ITEM FOR ENVIRONMENTAL COMMISSION AGENDA

NAME & NUMBER OF PROJECT: Concordia University Sports Complex, SP-2022-0020C

REQUEST: Variance request is as follows:
Request to vary from Lake Austin Watershed Ordinance No. 840301-F Section 9-10-409(b) to allow cut exceeding four feet to fifteen feet.

REQUEST: Variance request is as follows:
Request to vary from Lake Austin Watershed Ordinance No. 840301-F Section 9-10-409(a) to allow fill exceeding four feet up to twelve feet

CUT/FILL EXHIBIT
Concordia Unviersity
Sports Complex

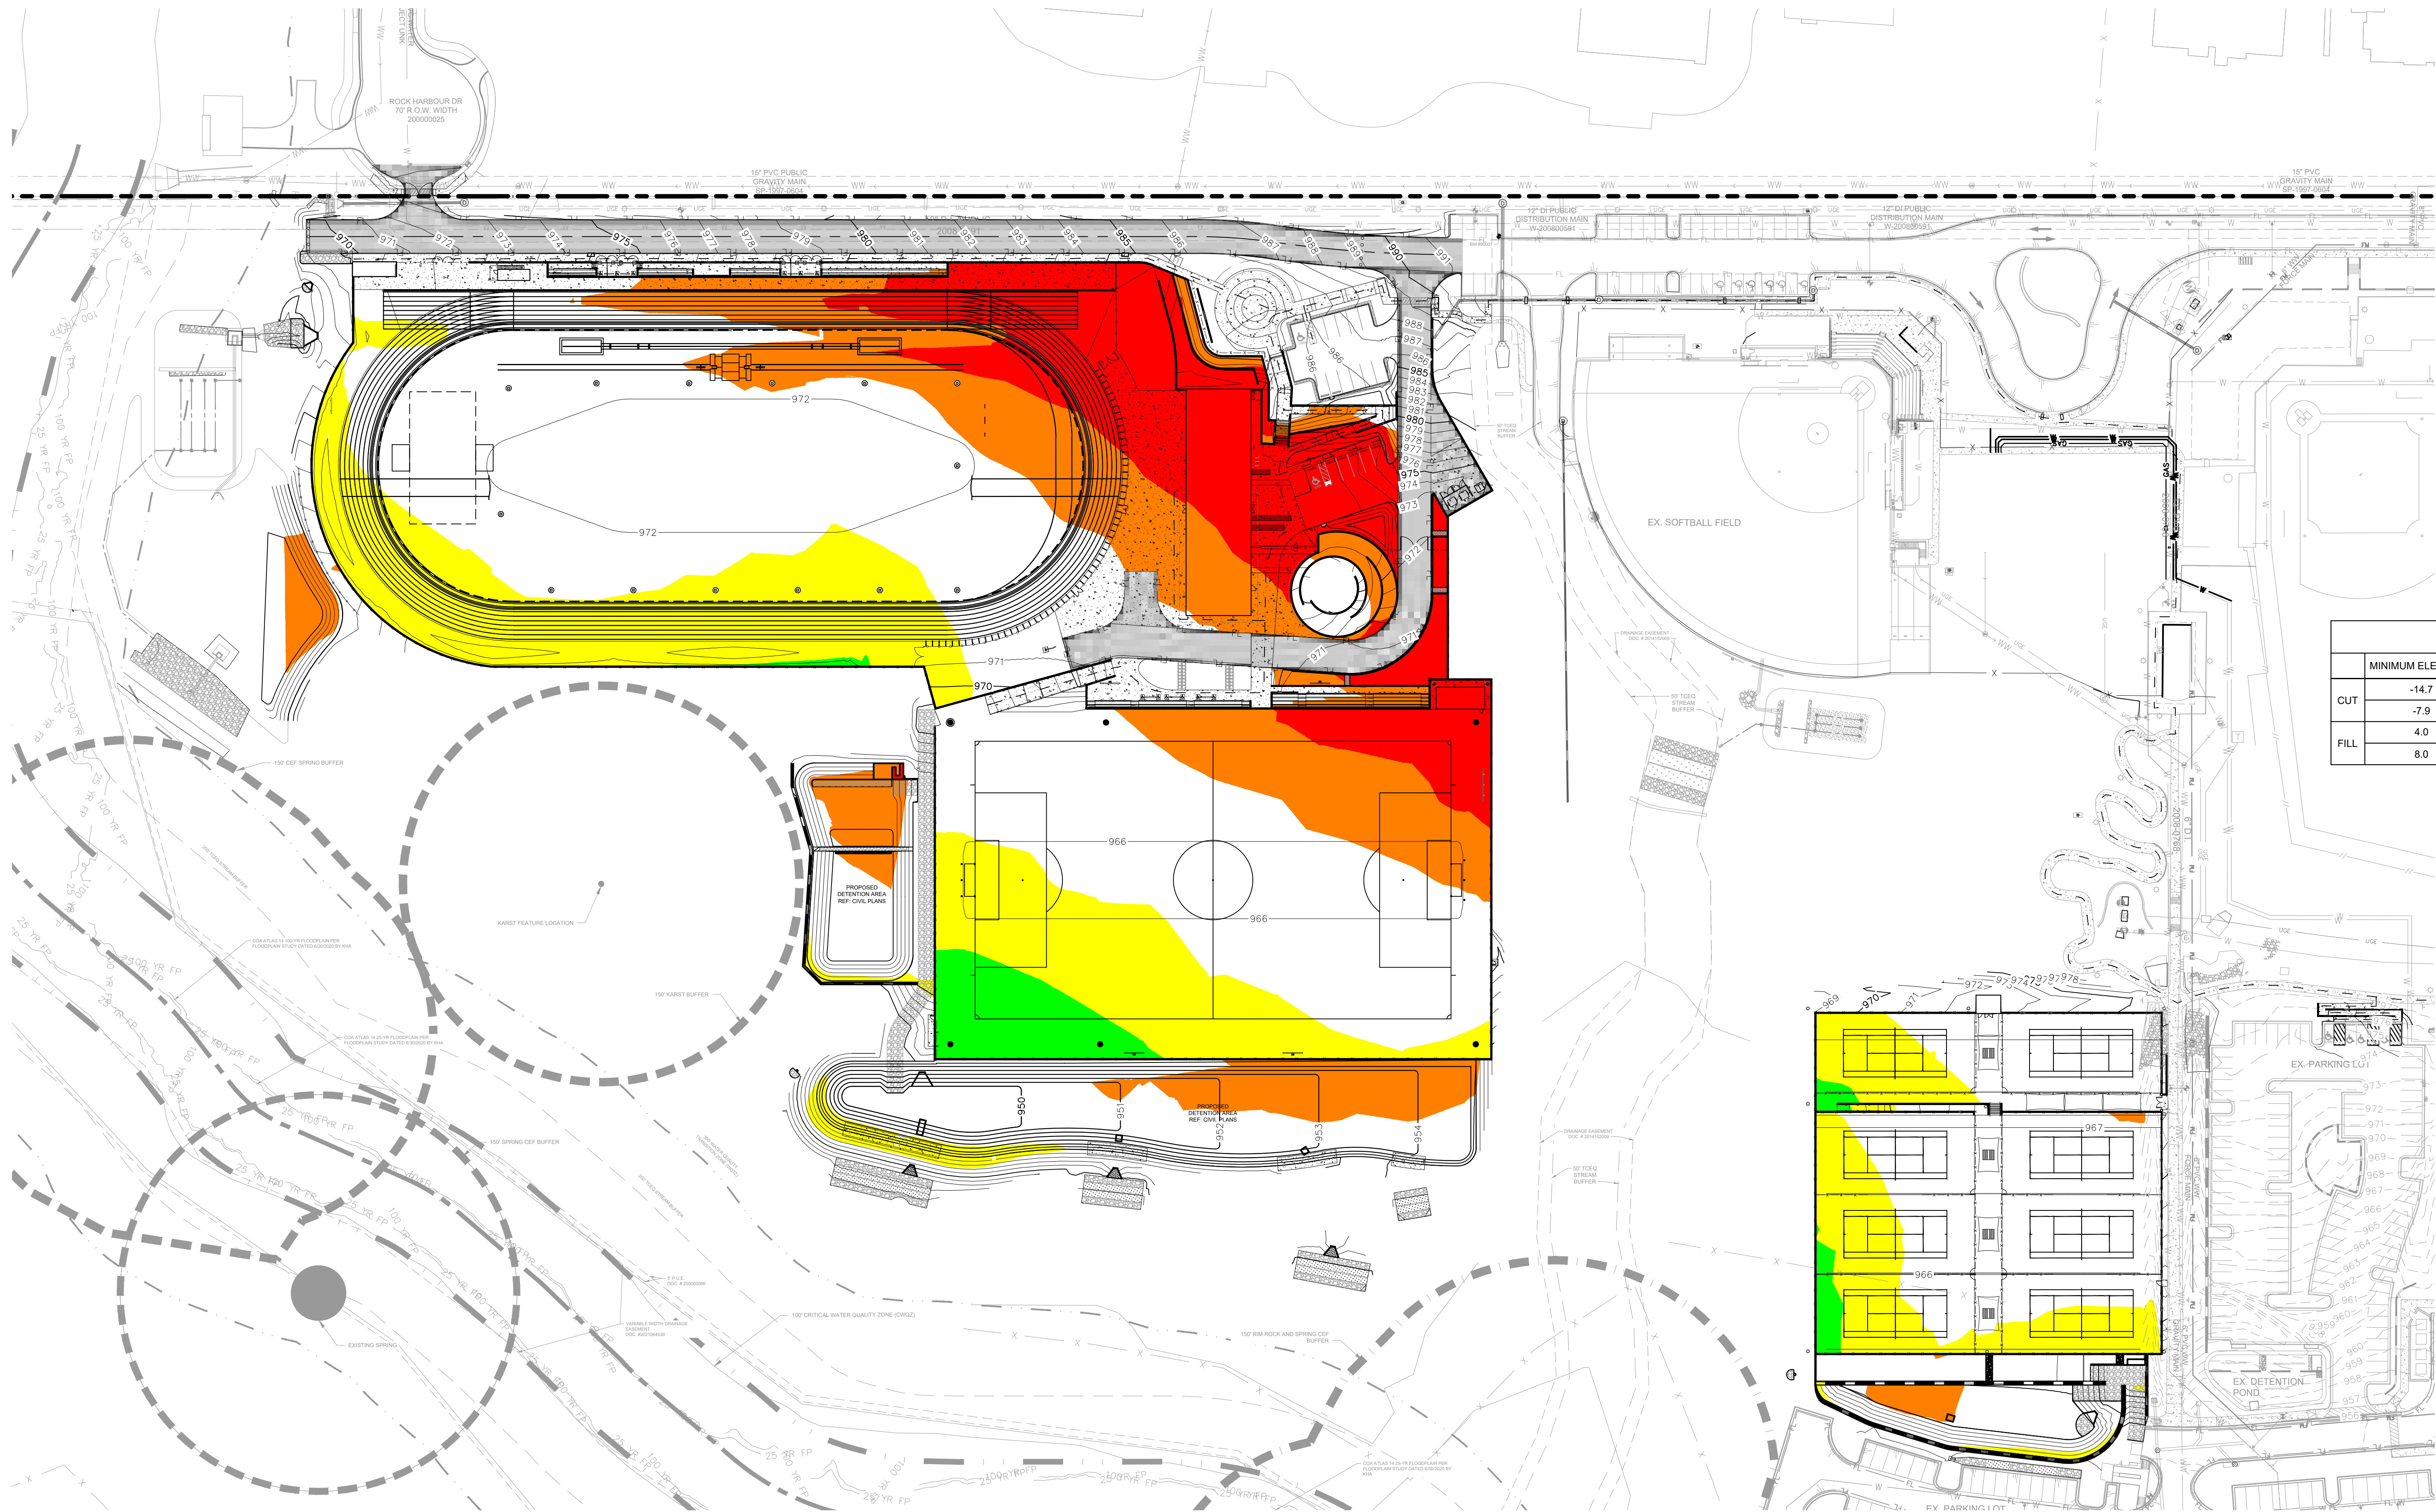
Please accept this letter as a request for a variance to the Lake Austin Ordinance #840301-F, Section 9-10-409(B) for a max cut of +/- 14.7 ft for the above referenced project.

Water and Waste Water service to be provided by	Austin Water Utility
Request	The variance request is as follows: The Variance Request is for a variance to the Lake Austin Ordinance #840301-F, Section 9-10-409(B) for a max cut of +/- 14.7 ft.

Please accept this letter as a request for a variance to the Lake Austin Ordinance #840301-F, Section 9-10-409(A) for a max fill of +/- 12.0 ft for the above referenced project.

Water and Waste Water service to be provided by	Austin Water Utility
Request	The variance request is as follows: The Variance Request is for a variance to the Lake Austin Ordinance #840301-F, Section 9-10-409(A) for a max fill of +/- 12.0 ft.

- 1) The site shall be graded so that no developed surface runoff drains to the CEF to the east of the track and field.
- 2) COA 609S native seeding and planting shall be installed in any disturbed area adjacent to the track and field.
- 3) A one-acre tract shall be dedicated as a conservation easement.

- 1) The site shall be graded so that no developed surface runoff drains to the CEF to the east of the track and field.
- 2) COA 609S native seeding and planting shall be installed in any disturbed area adjacent to the track and field.
- 3) A one-acre tract shall be dedicated as a conservation easement.

MAX CUT: ±14.7 FEET
MAX FILL: ±12.0 FEET
